UNITED STATES PATENT AND TRADEMARK OFFICE

APPLICATION NO.	FILING DATE	FIRST NAMED INVENTOR	ATTORNEY DOCKET NO.	CONFIRMATION NO.
10/779,451	02/13/2004	Brenda Lee Bailey	19948-17041	8964

Office Action Summary	Application No. 10/779,451	Applicant(s) BAILEY, BRENDA LEE	
	Examiner Michael G. Bogart	Art Unit 3761

DETAILED ACTION

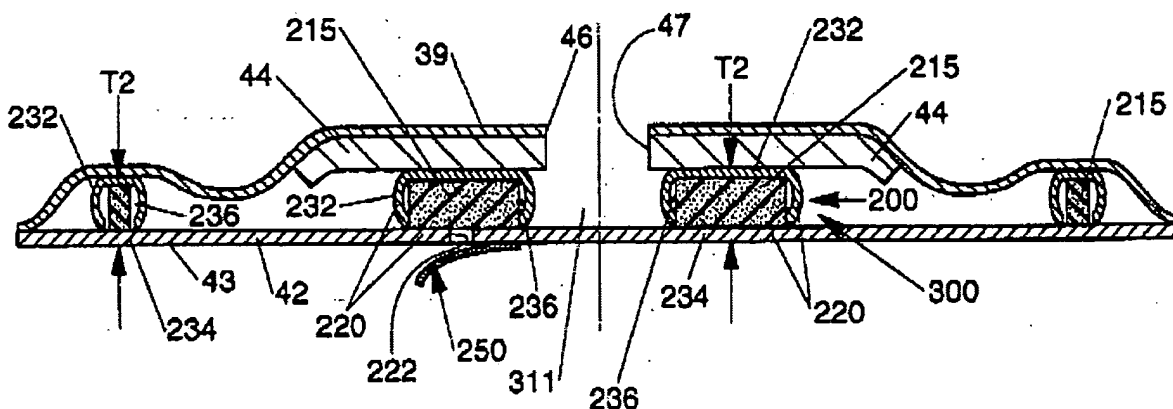
Claims 1-7 and 17 are rejected under 35 U.S.C. § 102(b) as being anticipated by Lavon *et al.* (US 5,520,674 A).

Lavon *et al.* teach diaper (20) comprising:

a first absorbent layer (44), including

a center portion (34);

wherein said center portion (34) has an inward facing surface (39) directed toward said user when said diaper (20) is worn and-an outward facing surface directed away from said user when said diaper (20) is worn;

a first opening (47);

a second absorbent layer (215), lying beneath said first absorbent layer (44), including a second opening (311) aligned with said first opening (47) which is larger than said first opening (47);

a sealing layer (42) lying beneath said second absorbent layer (215);

wherein said first opening (47), said second opening (311), and said sealing layer (42) combine to define a feces receiver lying proximate said outward facing surface;

wherein the increasing size of said first and second opening (47, 311) define an undercut side wall (235) in said feces receiver; and

wherein said first and second absorbent layers (44, 215) have sufficient strength to prevent the collapse of said feces receiver under the weight of said user (col. 2, lines 18-61; col. 11, lines 35-49)(see fig. 4, *infra*).

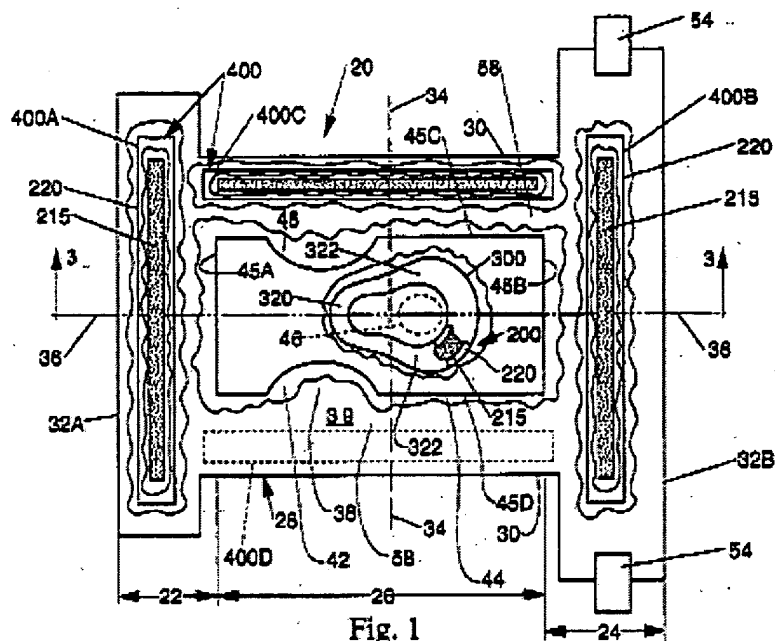
Regarding claim 2, Lavon *et al.* teach that the rear belt (24) has a first rear wing and a second rear wing;

said rear belt (24) includes closure means (54) located proximate said first rear wing and said second rear wing;

said front belt (22) has a first front wing and a second front wing; and

said front belt (22) includes closure means located proximate said first front wing and said second front wing (see figure 1, below).
